A	June	Planners comments	SDC:
rev:	date:	comment(s):	name: check:

job: **Keresley Grange School**

title: **Proposed Block Plan**

job no: **C4278** drg no: **005 Rev A**

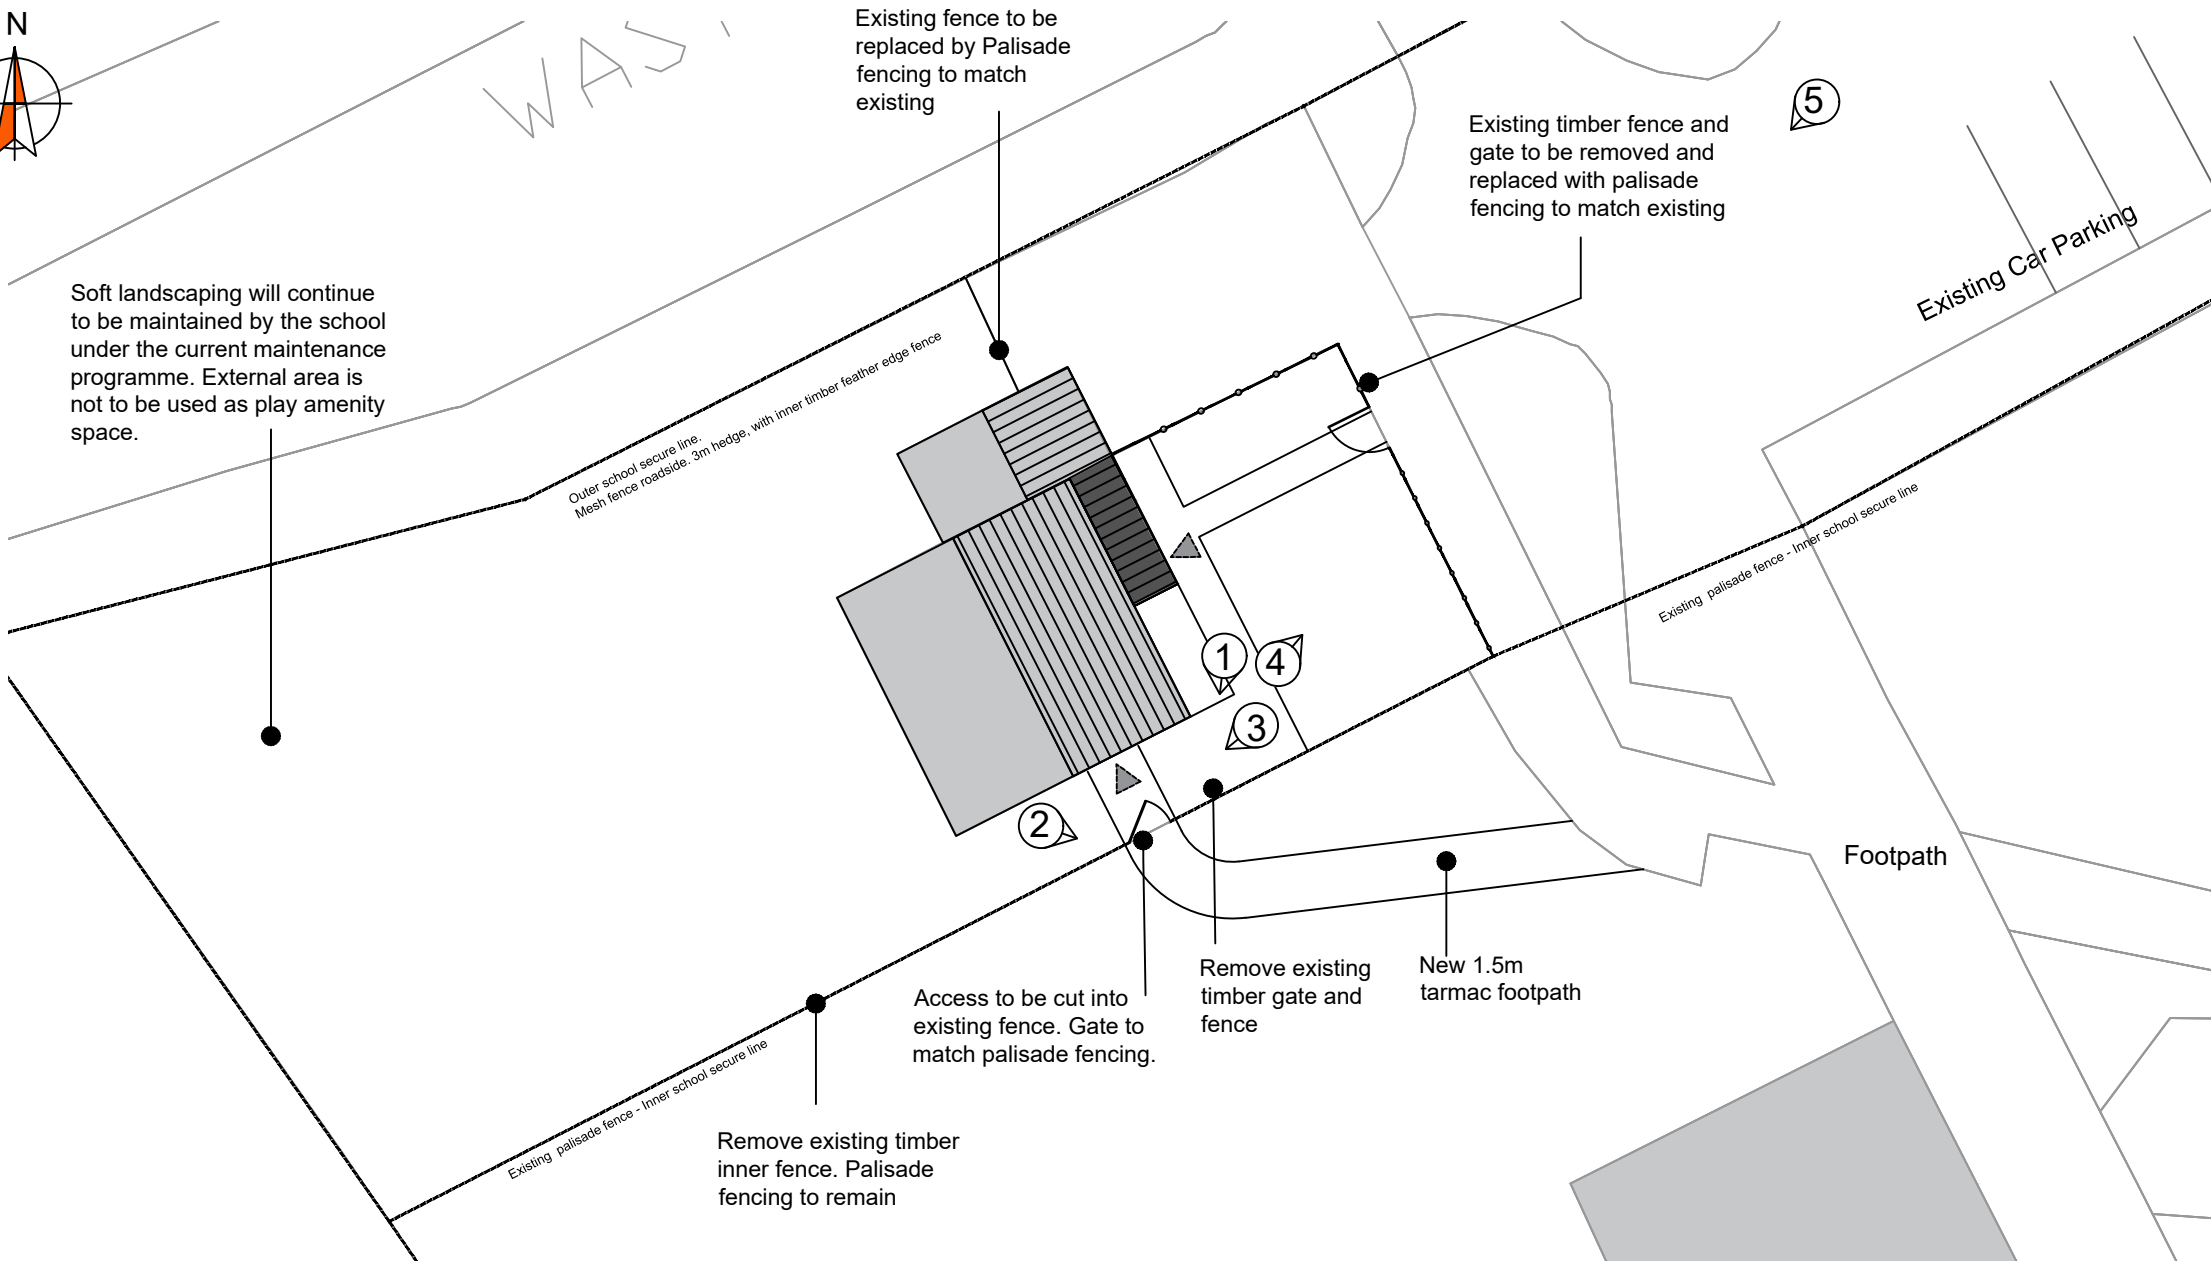
Existing fence to be replaced by Palisade fencing to match existing

Existing timber fence and gate to be removed and replaced with palisade fencing to match existing
